Document ID: IK1500057

Title: Davco Fuel Filter Replacements Recommendation for Maxx Force 11 and 13, 2010 Engines

Applies To: ProStar, WorkStar, TranStar

Figure 1 Identification of Standard Size Cover and Plus Size Cover and Collar

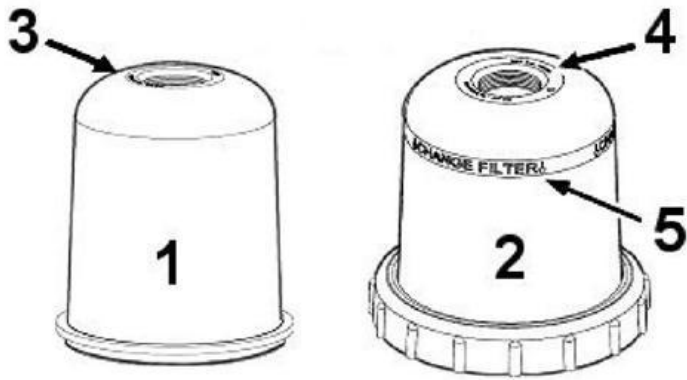
NOTE: If the standard size filter element is being replaced with a plus size filter element, the following cover /collar kit is required.

If the standard size filter element is being replaced with a plus size filter element, the plus size cover and collar (Filter 1) must be ordered.

2603439C1 Plus size cover and collar (Figure 1)
